# Proposed changes to London Luton Airport Arrivals

## SAIP AD6 Supplement:

Stansted Airport SID climb performance evidence  
supporting technical changes to altitude restrictions  
enabling the raising of CAS base levels

Figure 5 Stansted SID Rwy 04 CLN4S (conventional) – August 2019 illustration

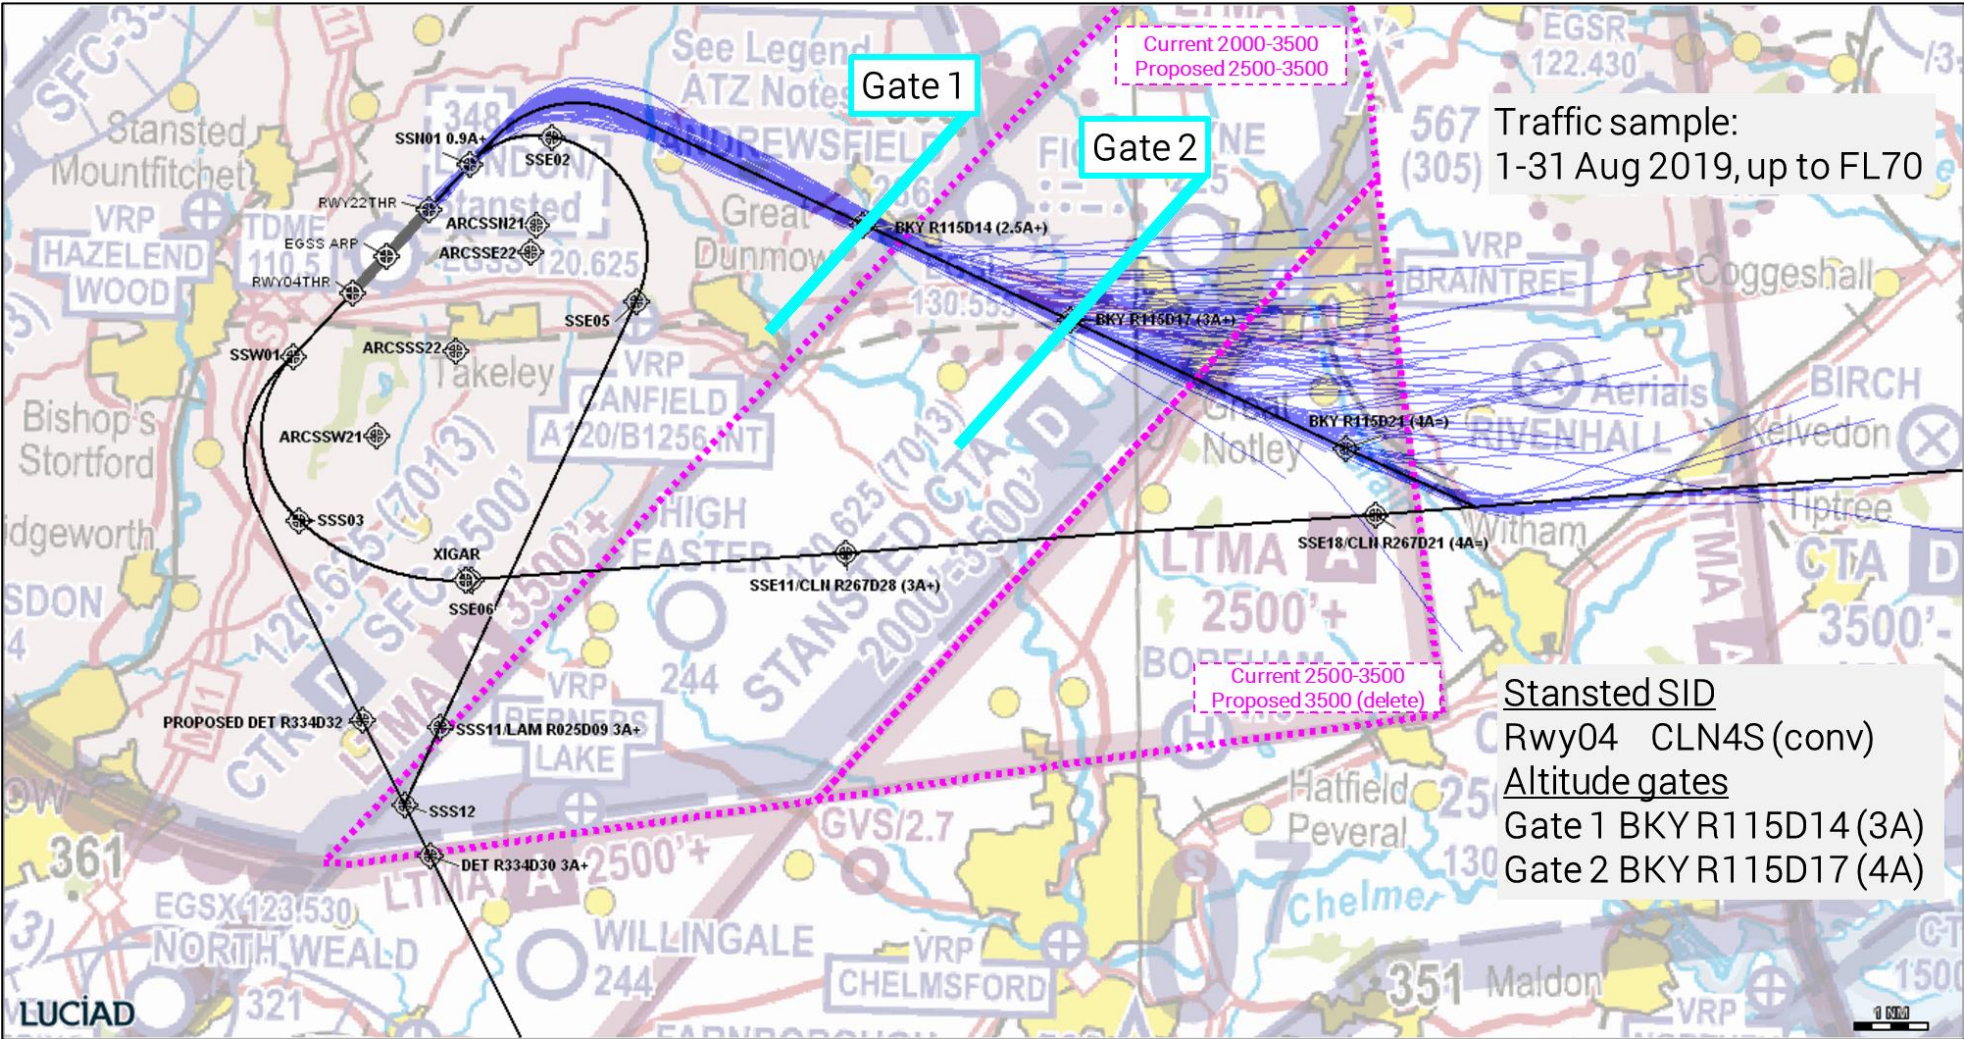
- 4.6.1 **Analysis Gate 1** was placed at BKY R115D14, designed to analyse aircraft at 3,000ft.  
One item of radar data was considered bad, indicating 0ft, and was excluded from subsequent analysis.

- 4.6.2 Of the remaining 4,803 departures, 4,801 (99.96%) met or exceeded an altitude of 3,000ft through the gate, which is 0.5nm before the next relevant CAS boundary (measured along the nominal track). Two (0.04%) were within 200ft which controllers would consider as 'achieved'<sup>1</sup>, and in this case both were actually within 100ft of Gate 1.

- 4.6.3 **Analysis Gate 2** was placed at BKY R115D17, designed to analyse aircraft at 4,000ft.  
One item of radar data was considered bad, indicating 0ft, and was excluded from subsequent analysis.

- 4.6.4 Of the remaining 5,658 departures, 5,636 (99.61%) met or exceeded an altitude of 4,000ft through the gate, which is 1.8nm before the next relevant CAS boundary (measured along the nominal track). Twenty (0.35%) were within 200ft which controllers would consider as 'achieved', and in this case 17 were actually within 100ft of Gate 2.

- 4.6.5 Of the remaining two flights through Gate 2:
- An A320 to Vienna achieving 3,500ft was compared with another A320 to Paphos on the same day, with Paphos 1,000nm further away from Stansted than Vienna (needing several tonnes of aviation fuel more than a flight to Vienna). The Paphos flight achieved 4,900ft.

- An A20N to Istanbul achieving 3,600ft was compared with another A20N of the same operator, to the same destination on the same day. The latter flight achieved 5,000ft.

- 4.6.6 Two flights in 121 days (0.04%) did not quite meet or exceed the Gate 2 analysis altitudes, given that a controller considers an altitude indication of within 200ft or less as 'achieved'.
- 4.6.7 Of those 2 flights, the Gate 2 analysis altitudes were met or exceeded by similar flights.
- 4.6.8 CAS containment assurance would be established, should climb restrictions be placed at the same locations as these gates.

Figure 6 Stansted SID Rwy 22 CLN8R (conventional) and CLN1E (RNP1) – August 2019 illustration

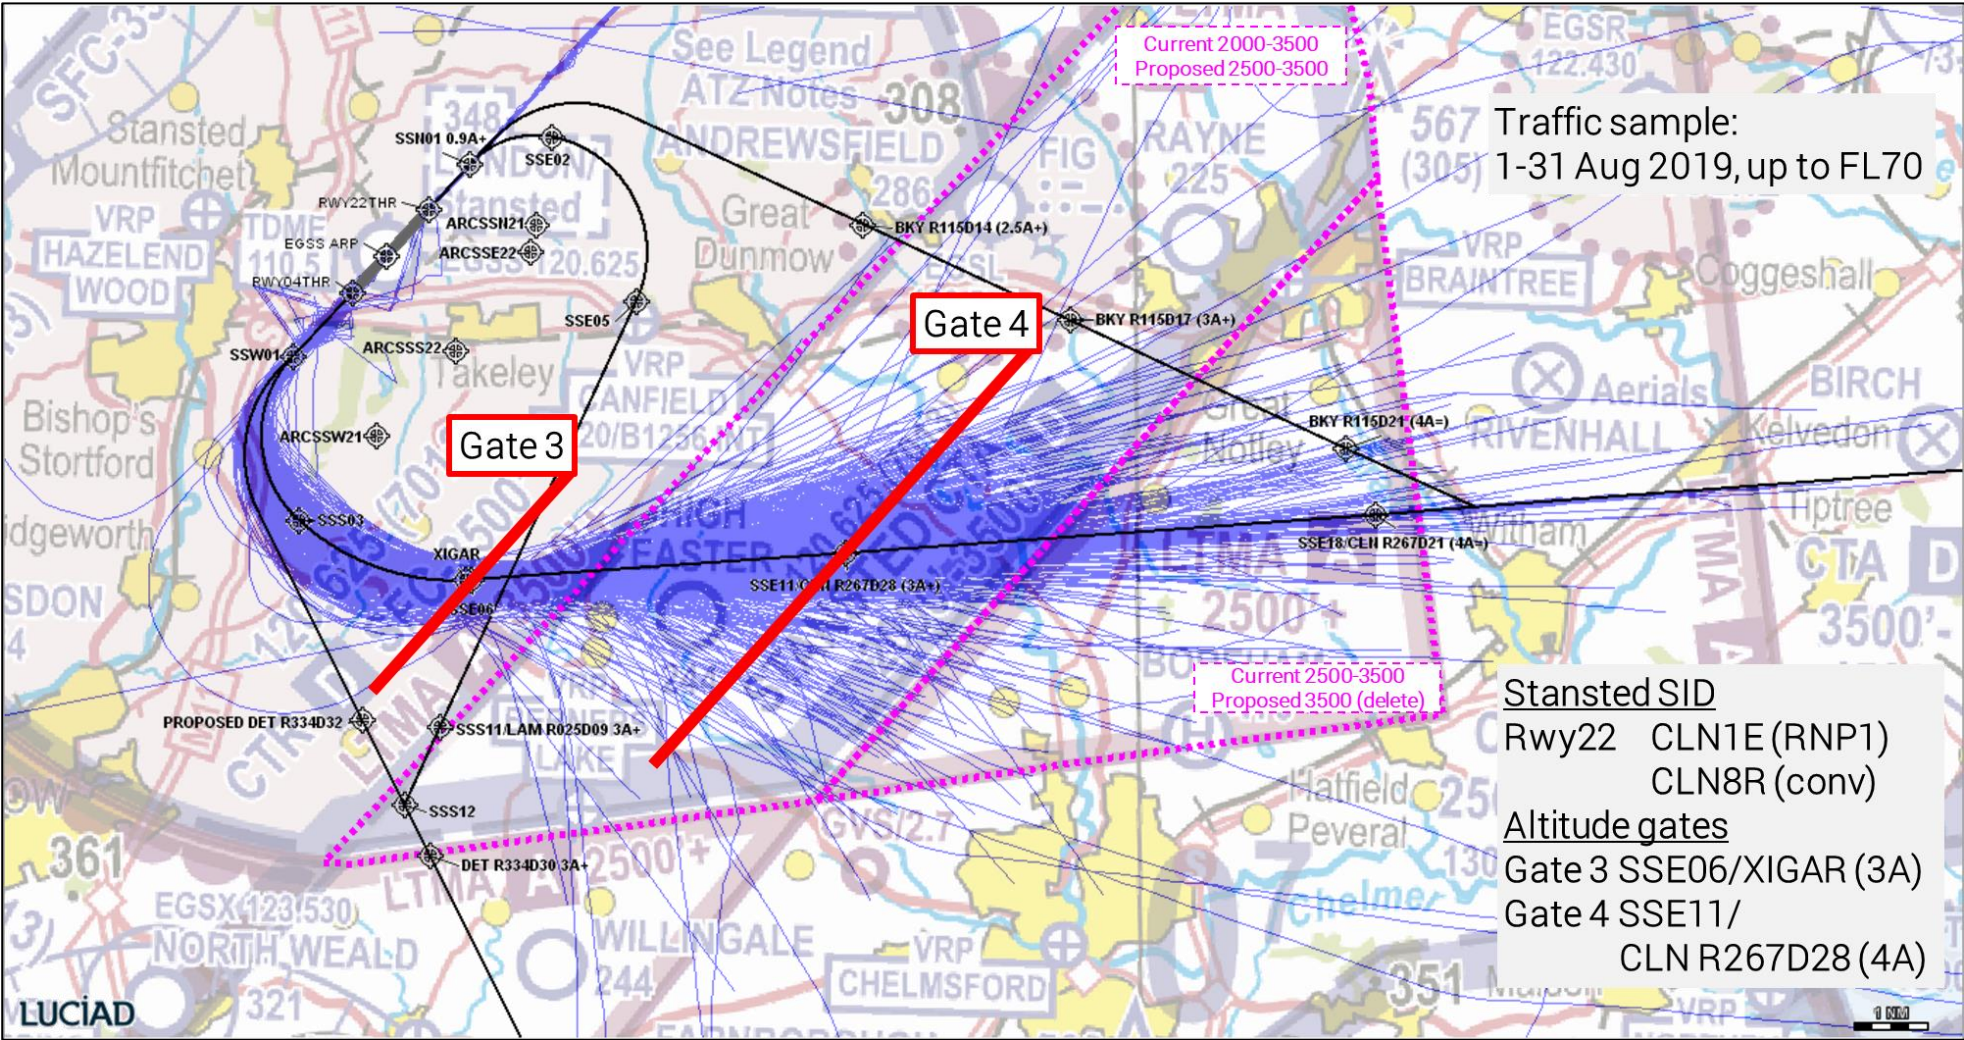
- 4.7.1 **Analysis Gate 3** was placed at SSE06/XIGAR, designed to analyse aircraft at 3000ft.  
Three items of radar data were considered bad, one indicating 0ft, two were flights unintentionally captured by the gate but were not using the SIDs of interest, and all three were excluded from subsequent analysis.

- 4.7.2 Of the remaining 13,770 departures, 13,733 (99.73%) met or exceeded an altitude of 3,000ft through the gate, which is 1.6nm before the next relevant CAS boundary (measured along the nominal track). Thirty one (0.23%) were within 200ft which controllers would consider as 'achieved', and in this case 25 were actually within 100ft of Gate 3.

- 4.7.3 Six flights (0.04%) met or exceeded 2,700ft through the gate. Each of the 6 were identified and compared with similar flights.
- An A320 to Larnaca achieving 2,700ft was compared with another A320 to Antalya, a similar distance. The Antalya flight achieved 3,500ft.

- 4.7.4 **Analysis Gate 4** was placed at SSE11/CLN R267D28, designed to analyse aircraft at 4,000ft.  
One item of radar data was considered bad, indicating 0ft, and was excluded from subsequent analysis.

- 4.7.5 Of the remaining 13,668 departures, 13,627 (99.7%) met or exceeded an altitude of 4,000ft through the gate, which is 2.8nm before the next relevant CAS boundary (measured along the nominal track). Forty one (0.3%) were within 200ft which controllers would consider as 'achieved', and in this case 40 were actually within 100ft of Gate 4.

- 4.7.6 Six flights in 121 days (0.04%) did not quite meet or exceed the Gate 3 analysis altitudes, given that a controller considers an altitude indication of within 200ft or less as 'achieved'.
- 4.7.7 Of those 6 flights, the Gate 3 analysis altitudes were met or exceeded by similar flights.
- 4.7.8 CAS containment assurance would be established, should climb restrictions be placed at the same locations as these gates.

Figure 7 Stansted SID Rwy 22 DET1R and LAM3R (conventional) – August 2019 illustration

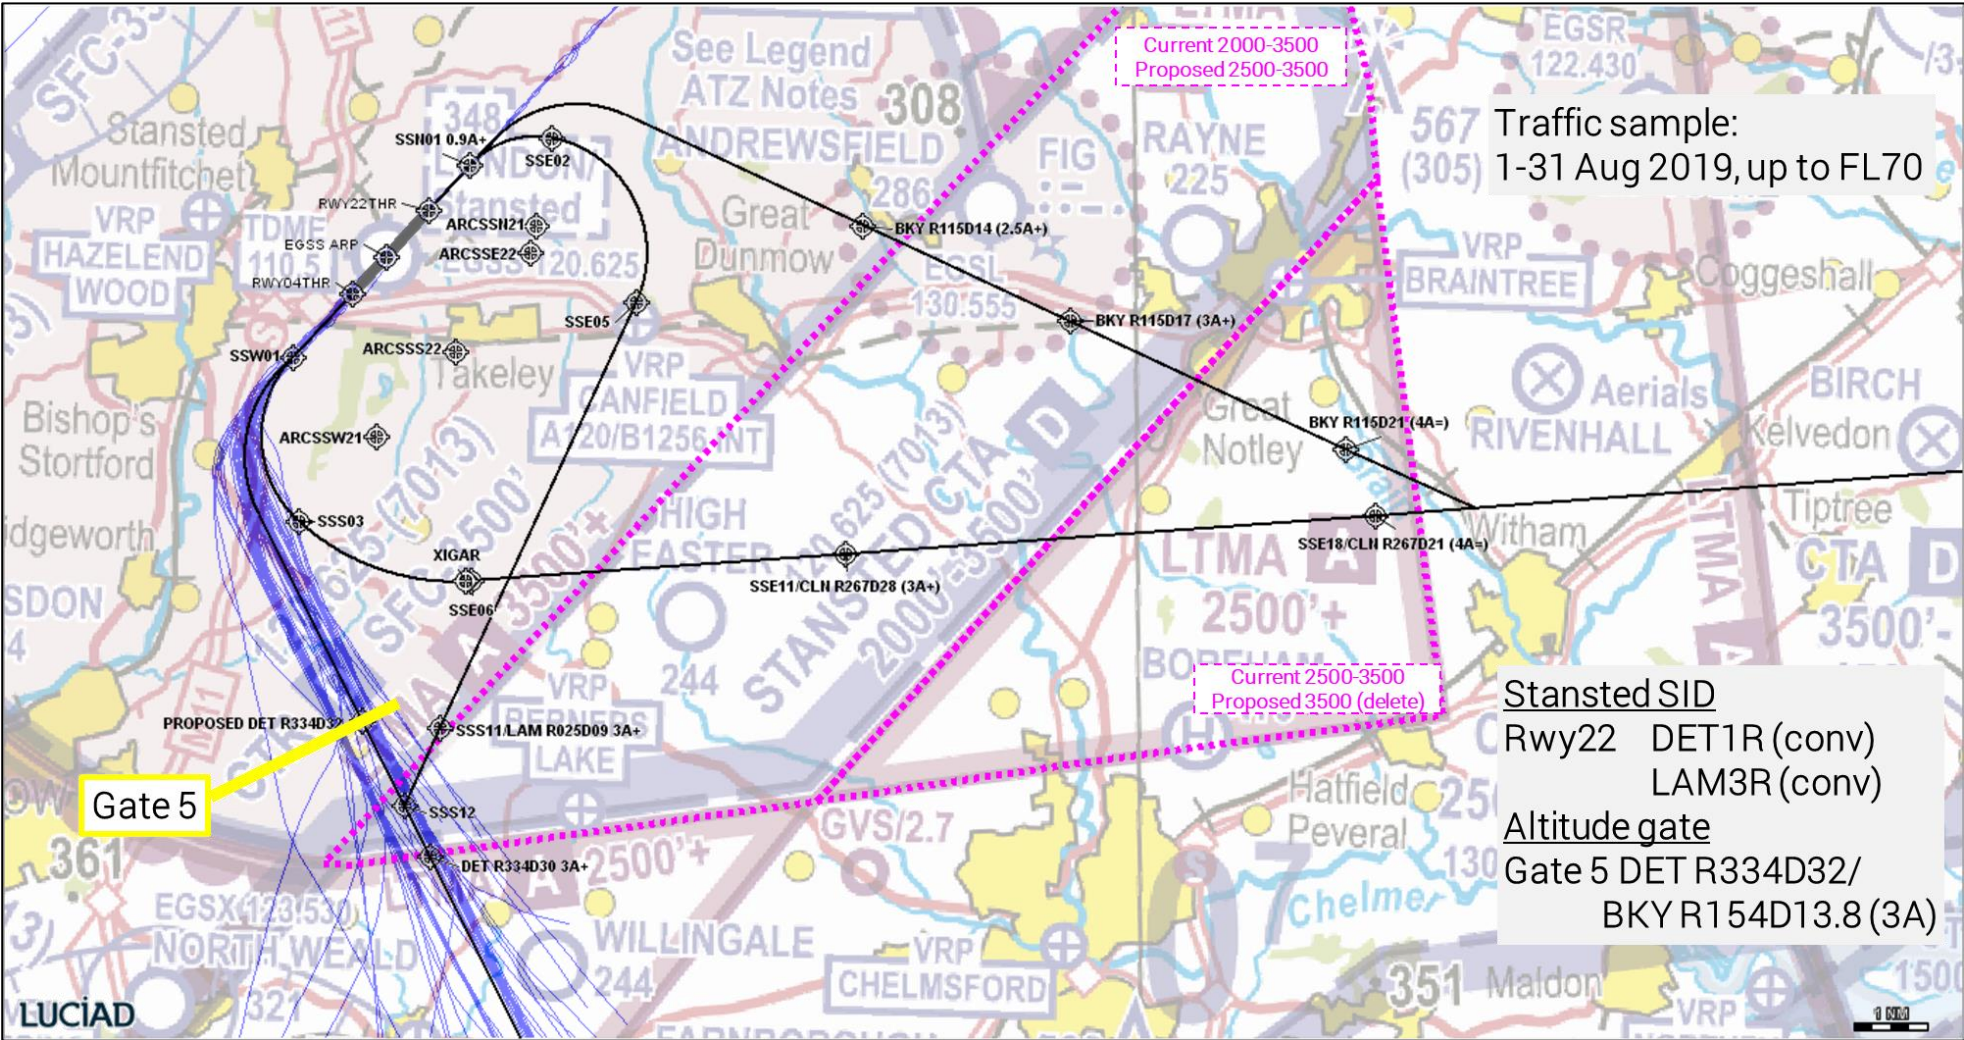
4.8.1 **Analysis Gate 5** was placed at DET R334D32/BKY R154D13.8, designed to analyse aircraft at 3,000ft.

4.8.2 There were 556 departures, all but one of which met or exceeded an altitude of 3,000ft through the gate, which is 1.0nm before the relevant CAS boundary (measured along the nominal track).

4.8.3 The remaining flight was actually within 100ft of Gate 5 and is considered to have 'achieved' the gate.

4.8.4 All flights using these SIDs in 121 days met or exceeded the Gate 5 analysis altitudes, given that a controller considers an altitude indication of within 200ft or less as 'achieved'.

4.8.5 CAS containment assurance would be established, should climb restrictions be placed at the same location as this gate.

Figure 8 Stansted SID Rwy 04 DET1S LAM 2S (conventional) and DET1D (RNP1) – August 2019 illustration, with Gate 5 and Gate 7 crossover highlighted

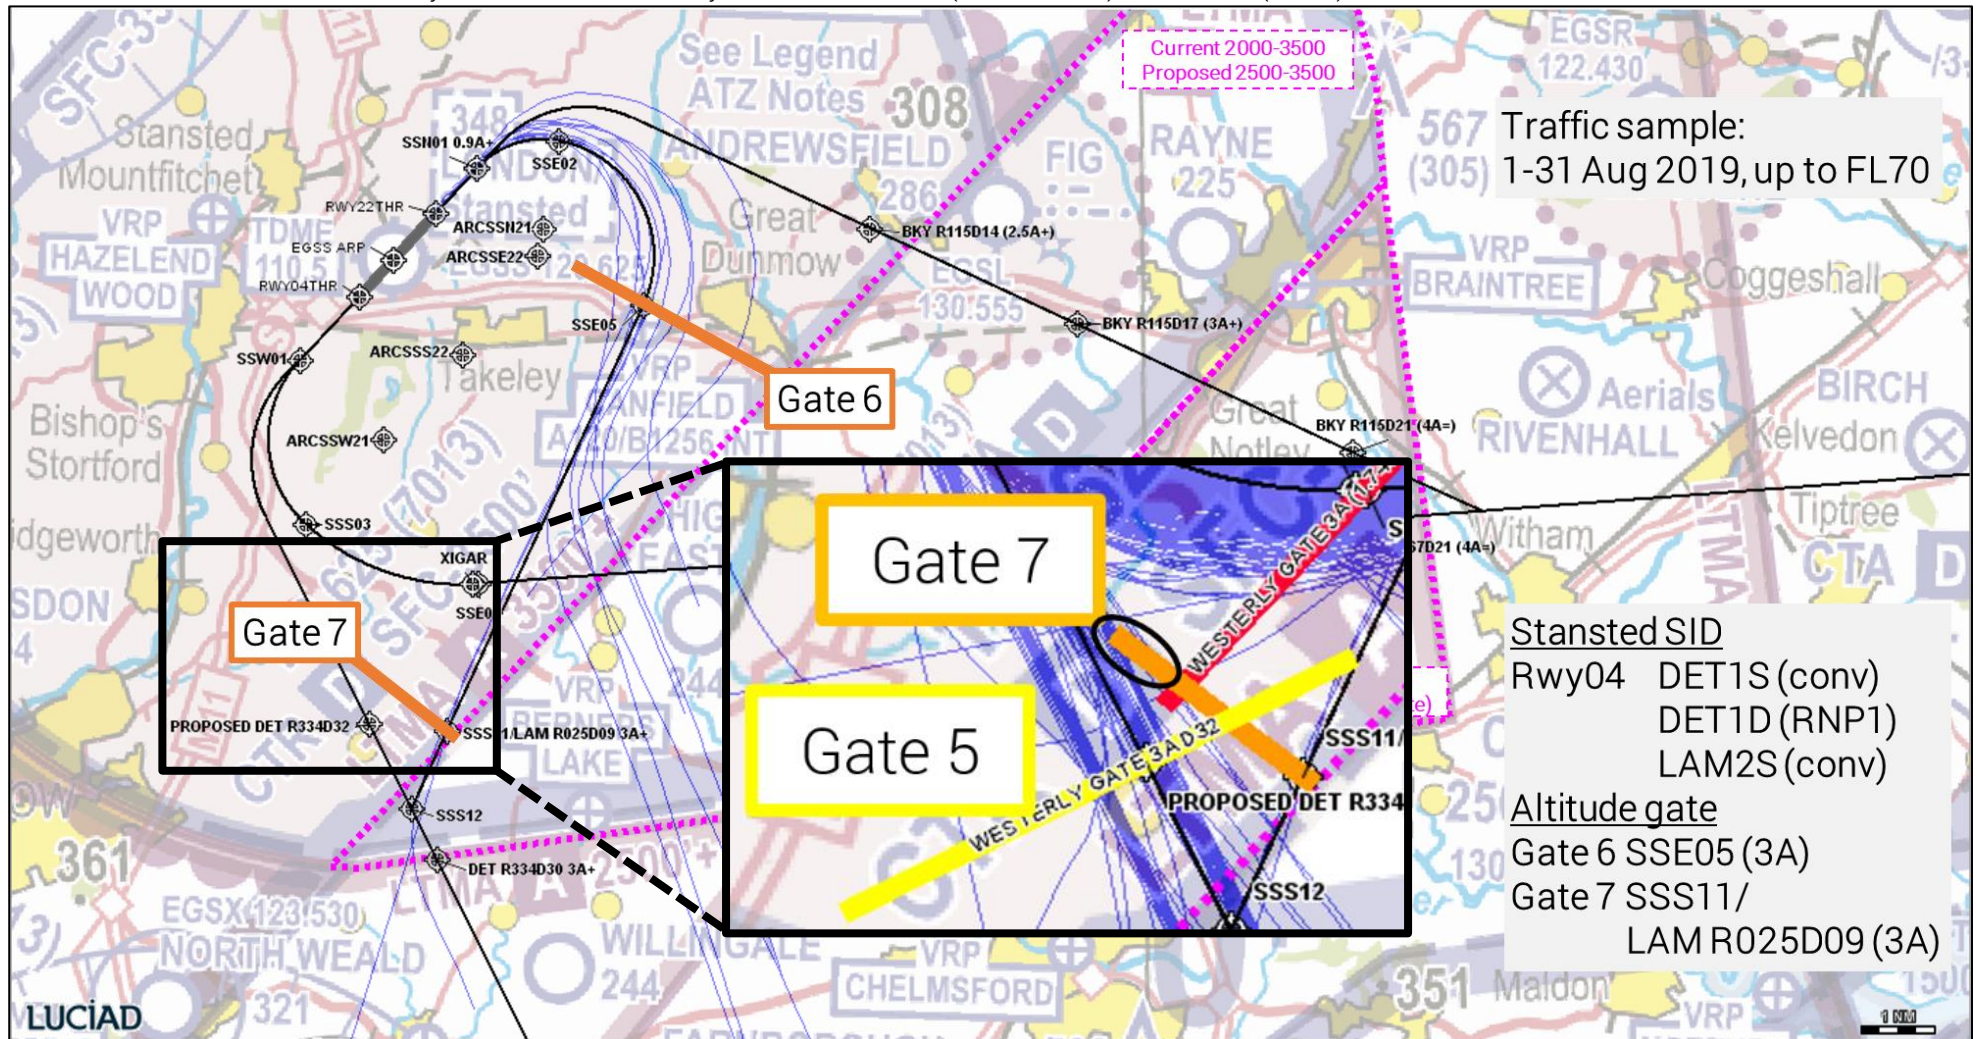
In the August illustration above, note that several DET-bound aircraft appear to have been turned directly to DET while still abeam the runway, thus avoiding Gate 7. A turn such as this is only allowable once the aircraft has attained an altitude of 4,000ft in accordance with EGSS-AD-2.21 Noise Abatement Procedures, assuring CAS containment for the areas of interest. This is a common controlling technique which complies with the Noise Abatement procedures and shortens the track to DET.

- 4.9.1 **Analysis Gate 6** was placed at SSE05, designed to analyse aircraft at 3,000ft.  
One item of radar data was considered bad, indicating 0ft, and was excluded from subsequent analysis.

- 4.9.2 Of the remaining 206 departures, all met or exceeded an altitude of 3,000ft through the gate, with 193 (93.6%) achieving or exceeding 3,500ft.
- 4.9.3 **Analysis Gate 7** was placed at SSS11/LAM R025D09, designed to analyse aircraft at 3,500ft that departed Rwy 04 via these SIDs.

- 4.9.4 Gate 7 'crosses' the Rwy 22 DET/LAM track, as per Gate 5 described previously. This means that several Rwy 22 flights are unintentionally captured by this gate, and more flights are counted through Gate 7 than Gate 6 which is counter-intuitive. This is highlighted in Figure 8 above. We inferred that those with a snapshot heading of between 150°-170° belong in Gate 5 for the Rwy 22 departures previously analysed, and can be removed from Gate 7 where the heading would be c.200-220°.

- 4.9.7 One flight achieved 3200ft, three achieved 3,300ft, and one achieved 3,400ft. However, studying the heading of these flights, all five were tracking between 150°-170°, thus they 'belong' in Gate 5 and not in Gate 7 and can be excluded from this Gate 7 analysis.

- 4.9.9 Gate 6 was set to understand how high aircraft typically achieve at the end of their first turn, and was not intended to set a new climb restriction.
- 4.9.10 Flights not meeting 3,500ft through Gate 7 were relevant to this analysis. Those 5 were all identified, their headings analysed, and all 5 'belong' to Gate 5.
- 4.9.11 Flights through Gate 5 that were unintentionally captured by Gate 7 remained included and their headings were not analysed. As long as any flight met or exceeded the analysis altitude, no further study was necessary because its purpose was to identify all flights that underperformed the altitude parameter of 3,500ft.
- 4.9.12 All eligible flights in 121 days met or exceeded the analysis altitudes of both gates.
- 4.9.13 CAS containment assurance would be retained, should a climb restriction be placed at the same location as Gate 7.
